CITY OF SHERWOOD
July 23, 2020
Staff Report

RIVERSIDE AT CEDAR CREEK
28-LOT SUBDIVISION
LU 2020-005 SUB

PROPOSAL: The applicant is proposing a 28-lot single-family detached residential subdivision on a 10.47-acre site. The subject site is located in the City of Sherwood within the Brookman Road Concept Plan area and is zoned Medium Density Residential Low (MDRL). The proposed lot sizes range from 4,722 SF to 8,135 SF with an average lot size of 5,914 SF. The applicant is proposing to preserve approximately 203,158 SF (4.66 acres) of open space including the Cedar Creek vegetated corridor, wetlands, and floodplain. A new community trail will be constructed along the north side of the creek and provide a pedestrian connection to SW Brookman Road. Street improvements will include a through connection and complete street improvements to SW Wapato Lake Drive (local street) and 1/4 street improvements to SW Trillium Lane (local street).

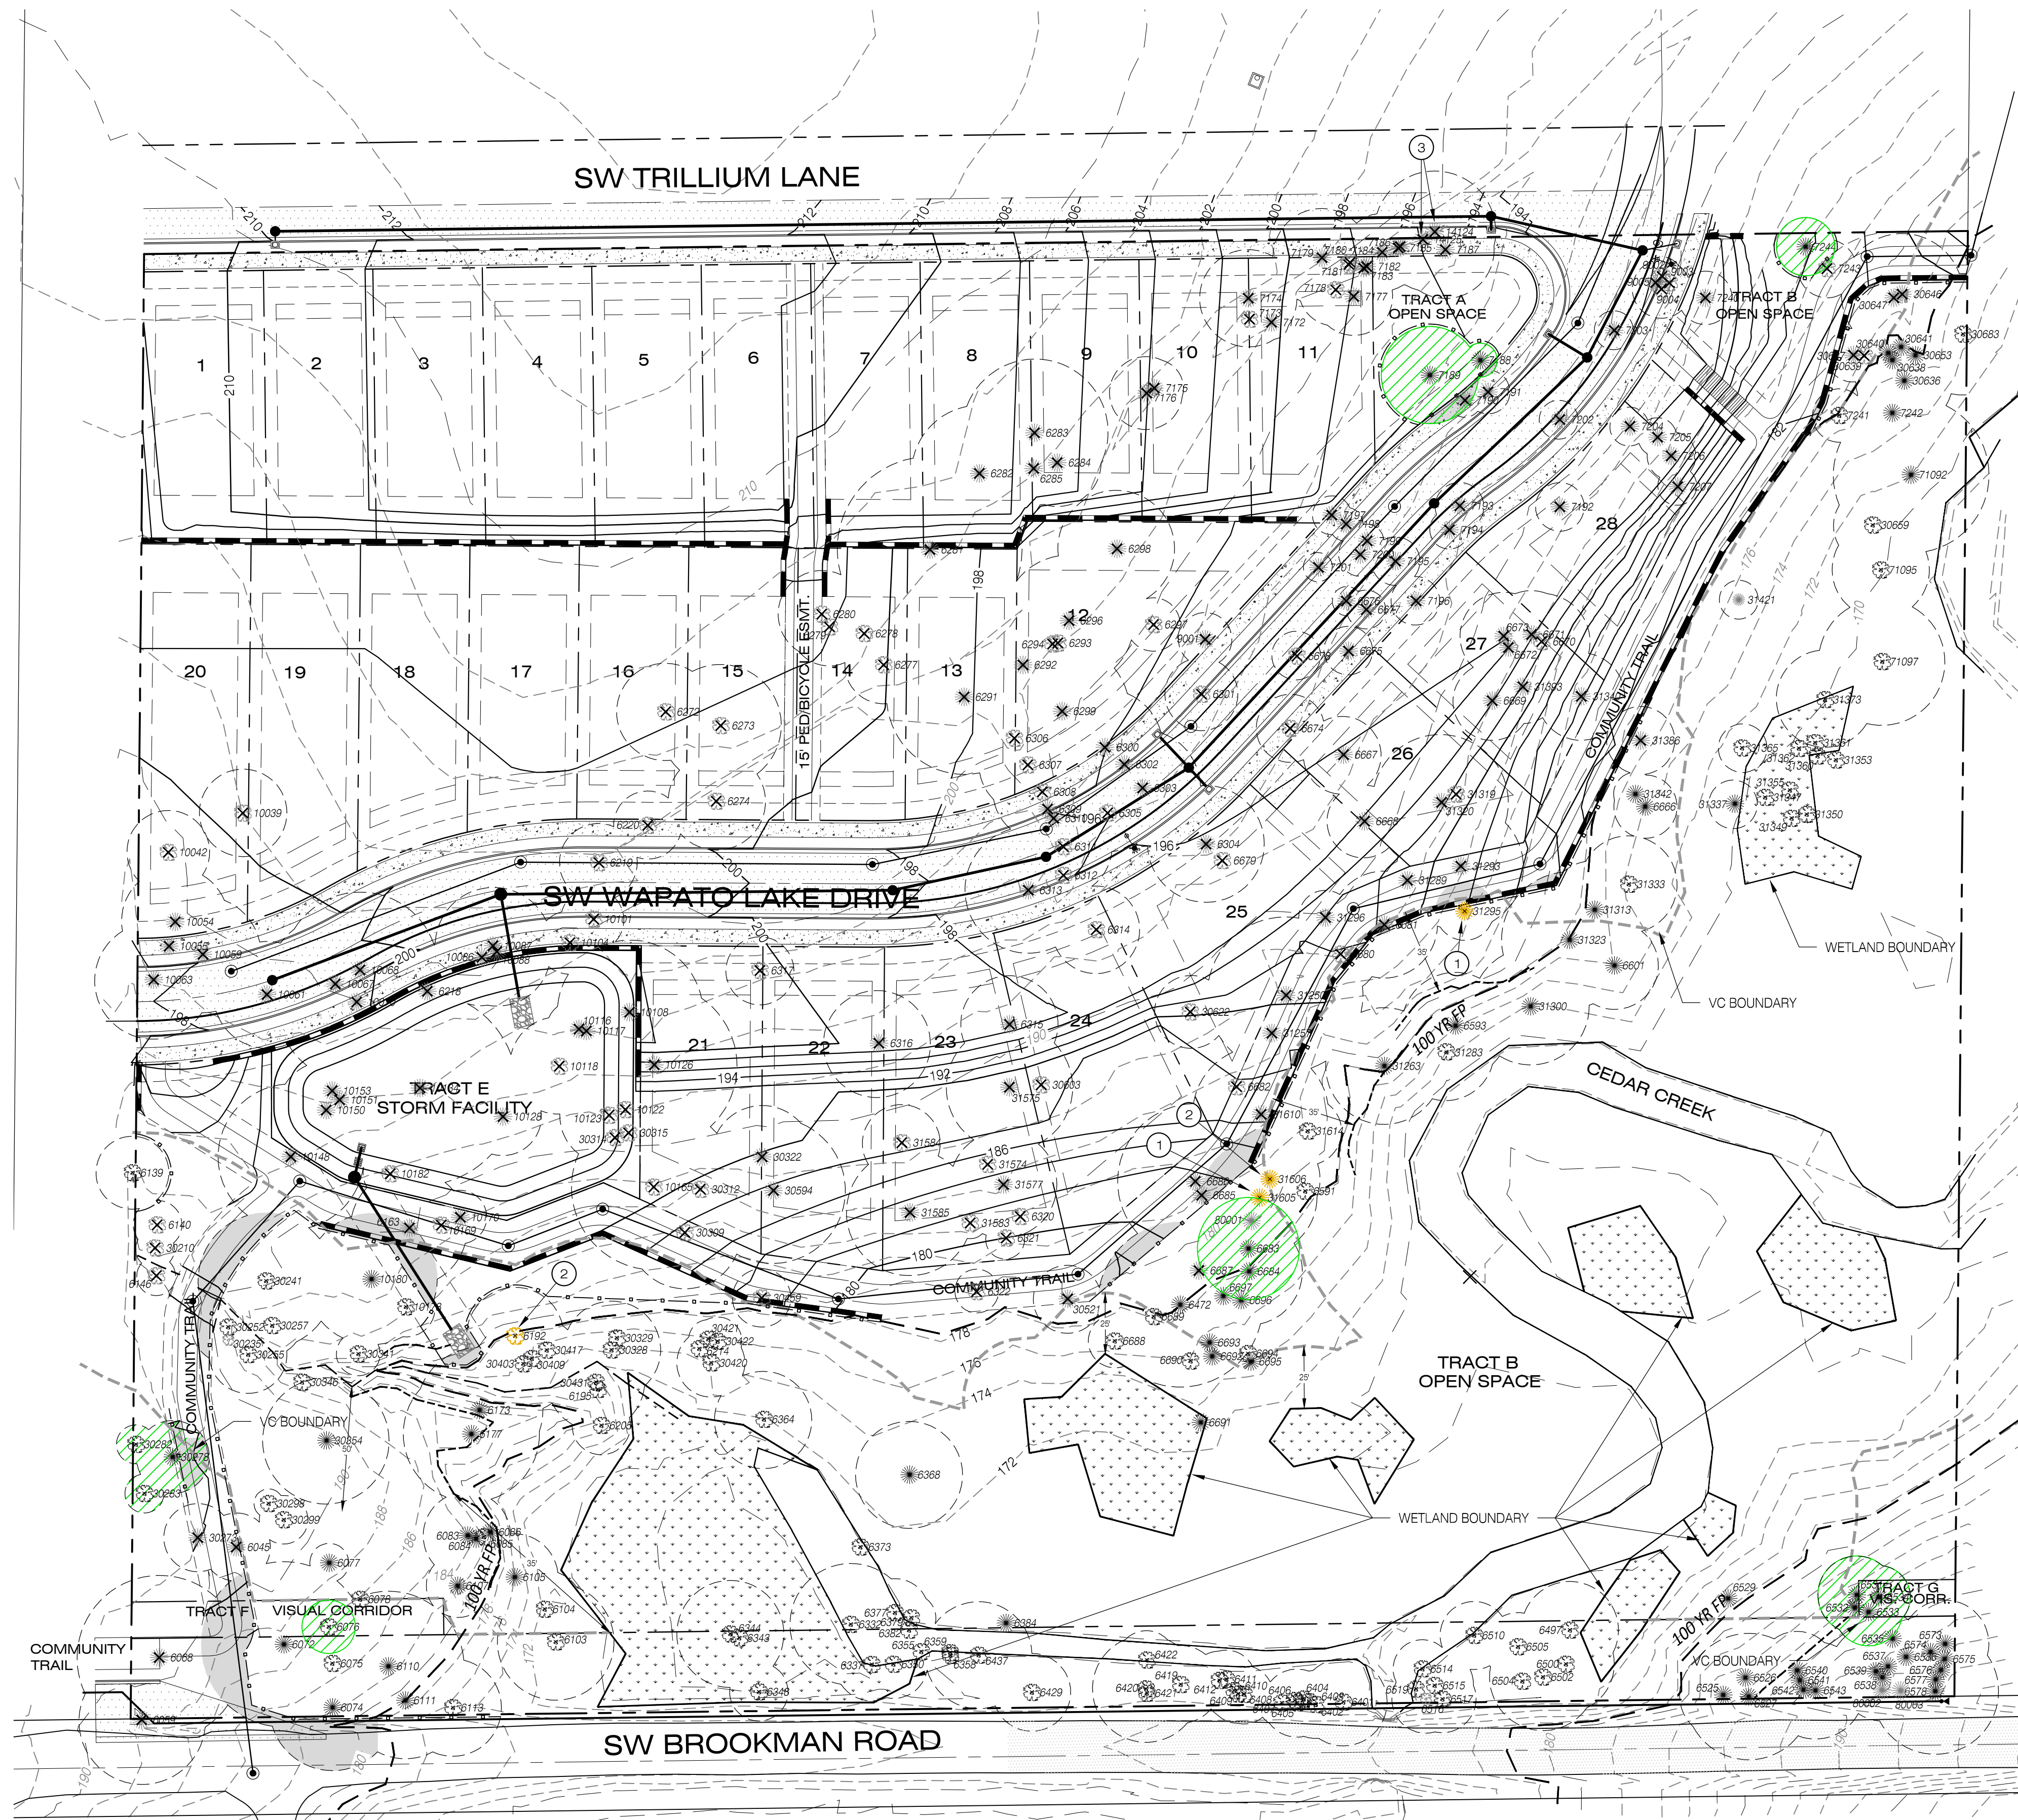
ANALYSIS: The applicant has submitted a Preliminary Tree Preservation and Removal Plan (Exhibit A15 – Sheet P3) which is supported by an arborist report from Morgan Holen & Associated (Exhibit A8). As described in SZCDC § 16.142.070 below, the proposal complies or is conditioned to comply with the applicable tree protection standards.

FINDING: This applicant has submitted a Preliminary Tree Preservation and Removal Plan (Exhibit A15 – Sheet P3) and an Arborist Report (Exhibit A8) that maps and describes trees as required by this section. Details of the preservation and removal plan are discussed below.

ANALYSIS: The Notice of Decision will include the Exhibit A15 – Sheet P3 Tree Preservation Plan and any modifications to the plan as may be required by the Hearing Authority.

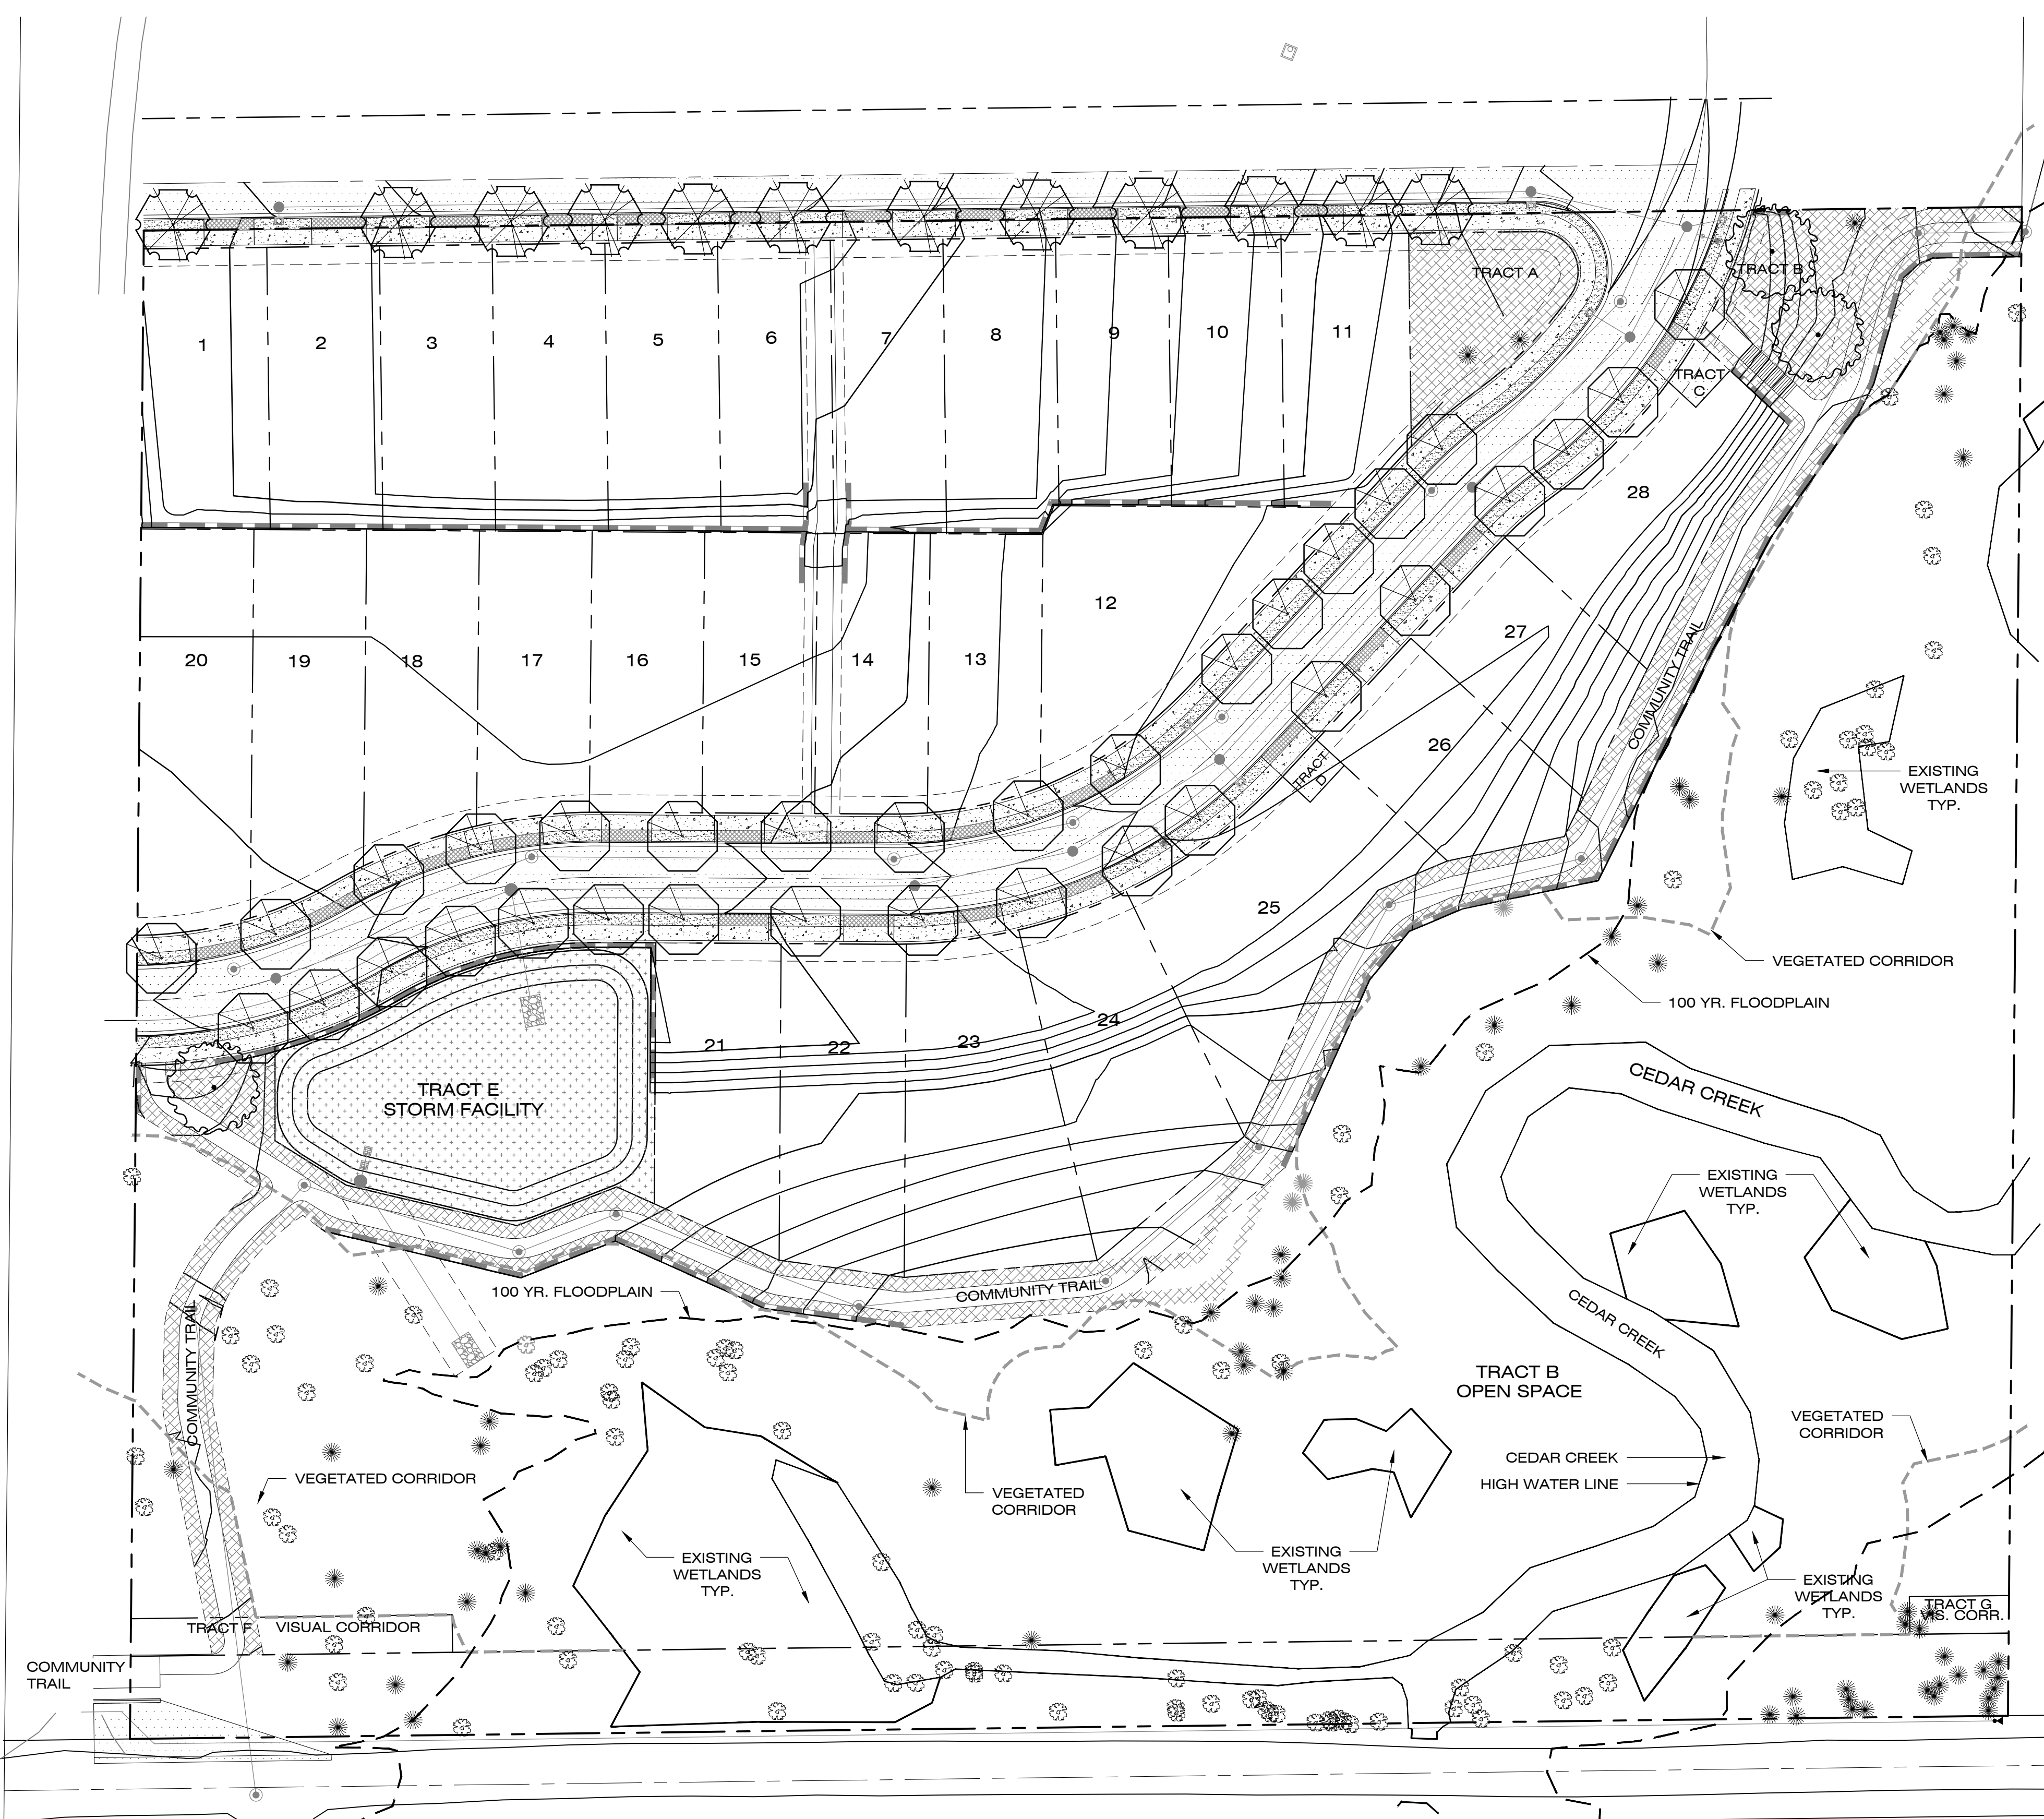
RECOMMENDED CONDITION OF APPROVAL B3: Prior to final plat approval, revise the Preliminary Street Tree & Open Space Planting Plan (Exhibit A15 – Sheet L1) to provide landscaping in accordance with the clear vision requirements of SZCDC § 16.58.010(C).

ANALYSIS: The applicant has submitted a Preliminary Street Tree and Open Space Planting Plan (Exhibit A15 – Sheet L1) that shows new landscaping will be provided in the following areas:

Exhibit A15 – Sheet L2 provides the size and species of the proposed plantings in accordance with the standards above. A detailed planting plan showing the location and quantity of plantings within the landscaped areas has not been provided.

The City’s Recommended Street List indicates the canopy spread of both trees is 40 ft. The scaled Preliminary Tree Plan (Exhibit A15 – Sheet L1) shows that no street trees will be spaced greater than 40 ft. unless adjacent to open space where existing mature trees provide canopy cover. The final location of street trees will be determined with the final plat and final engineering plan review.

3. Prior to final plat approval, revise the Preliminary Street Tree & Open Space Planting Plan (Exhibit A15 – Sheet L1) to provide landscaping in accordance with the clear vision requirements of SZCDC § 16.58.010(C).

12.50.710.C.5 Detailed Design Elements Garage Façade (4 elements)

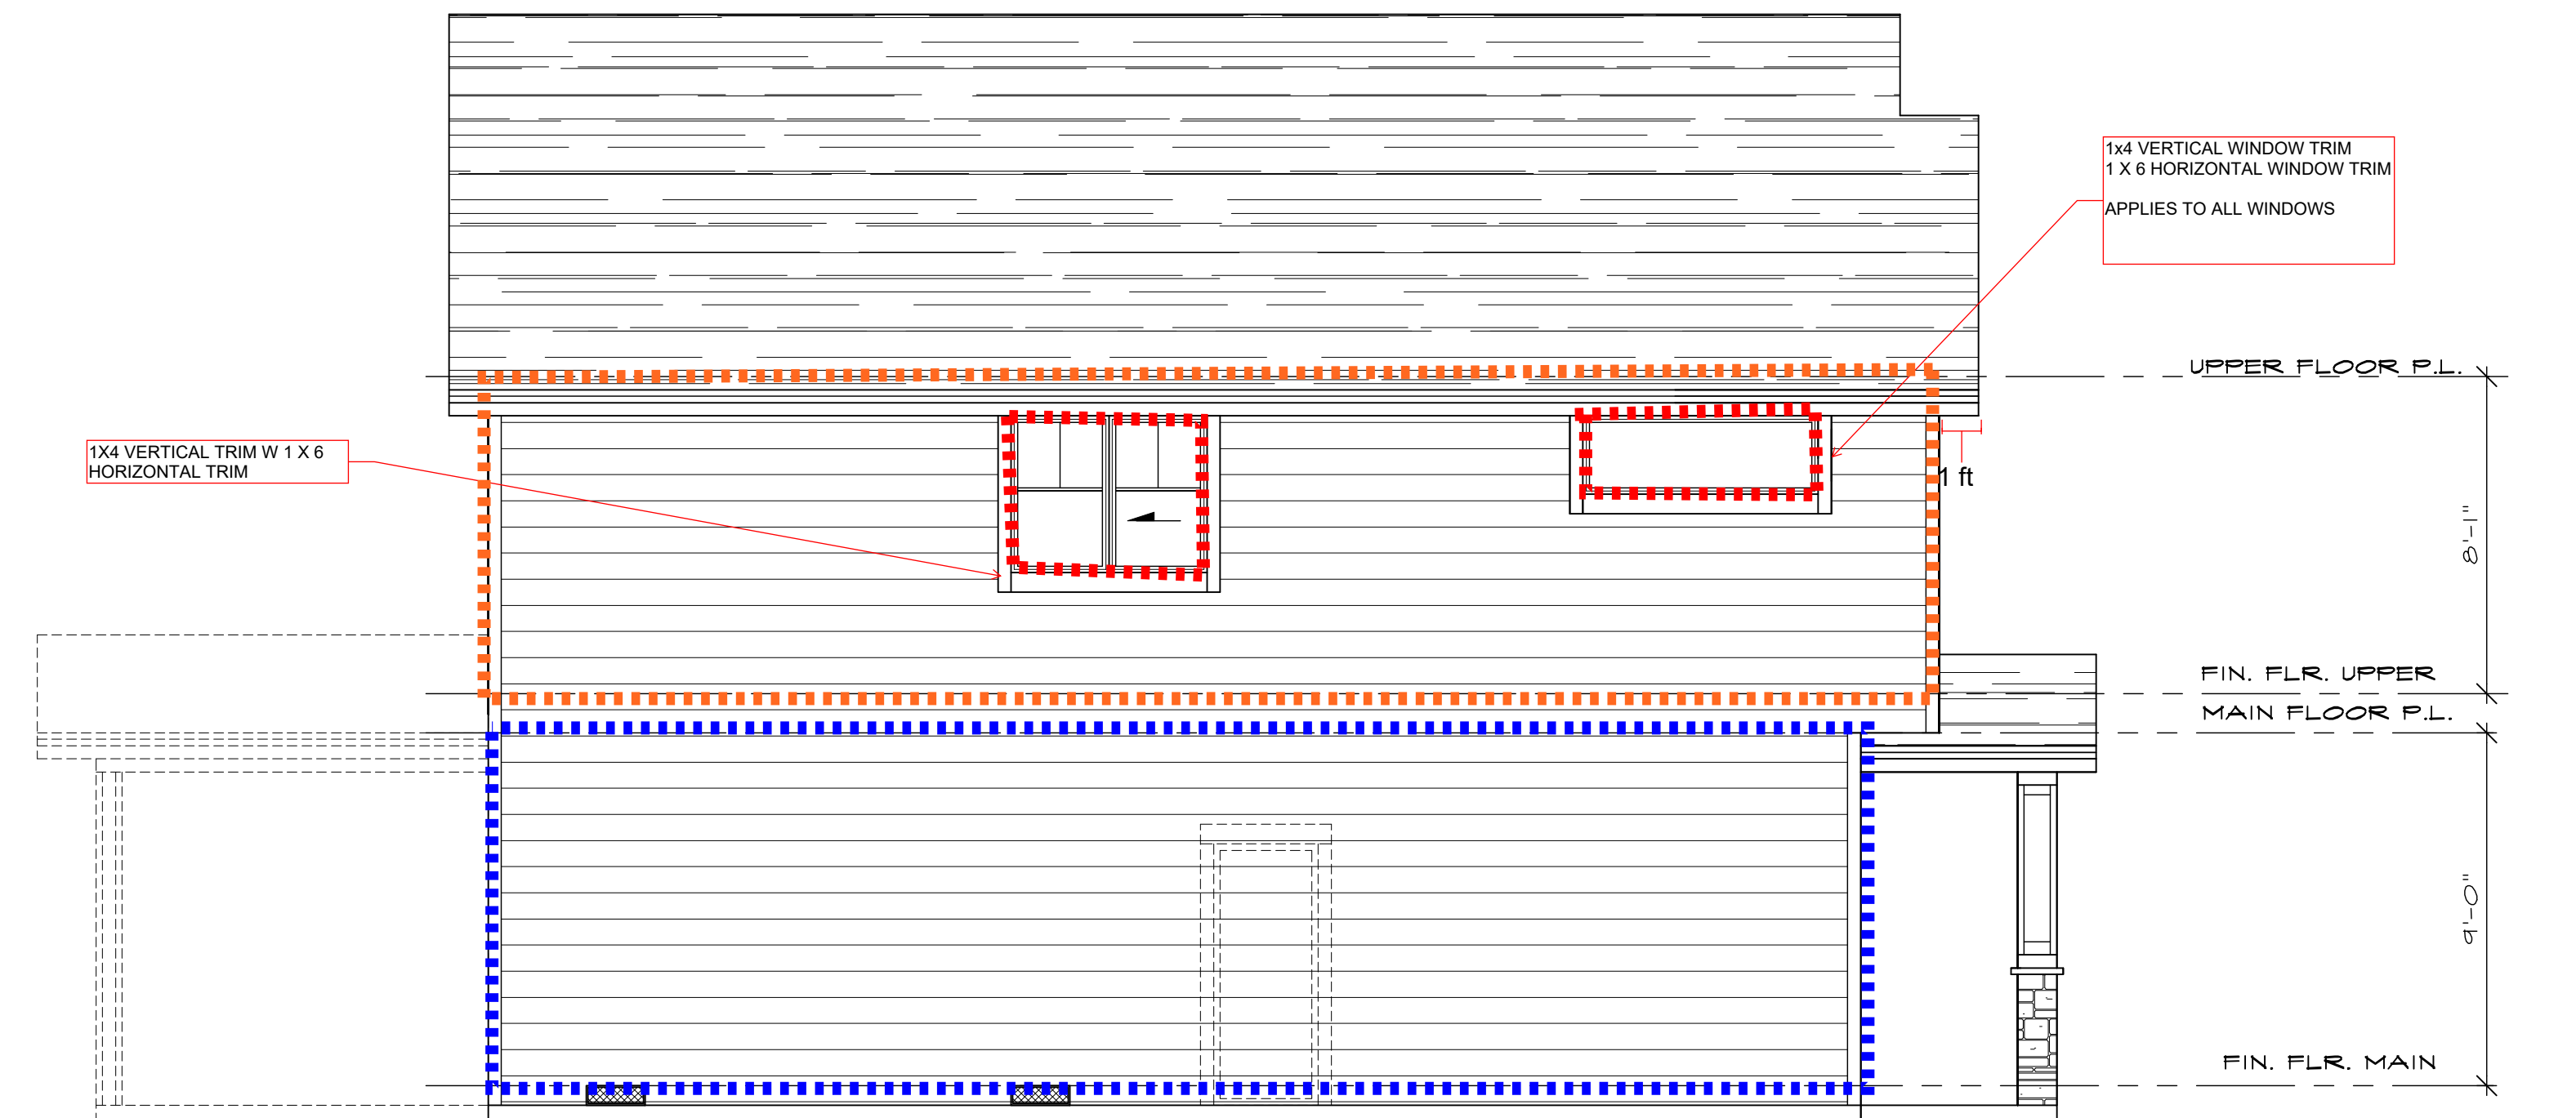
façade meets or exceeds the level of architectural detail provided in the “Enhanced Elevation” drawing shown in Exhibit C1. The actual architectural features provided may differ from the elevation shown in the exhibit but shall be provided at the quantity shown in the plans.

1. Prior to issuance of building permits for Lot 25, a plot plan shall be submitted that identifies the lot line abutting the public street as the front lot line. The plot plan shall show the front, rear, and side setbacks meet the requirements of the MDRL zone, unless a variance is approved that allows otherwise.
2. Prior to issuance of building permits for Lot 28, submit elevation plans that demonstrate the public street facing façade meets or exceeds the level of architectural detail provided in the “Enhanced Elevation” drawing shown in Exhibit C1. The actual architectural features provided may differ from the elevation shown in the exhibit but shall be provided at the quantity shown in the plans.
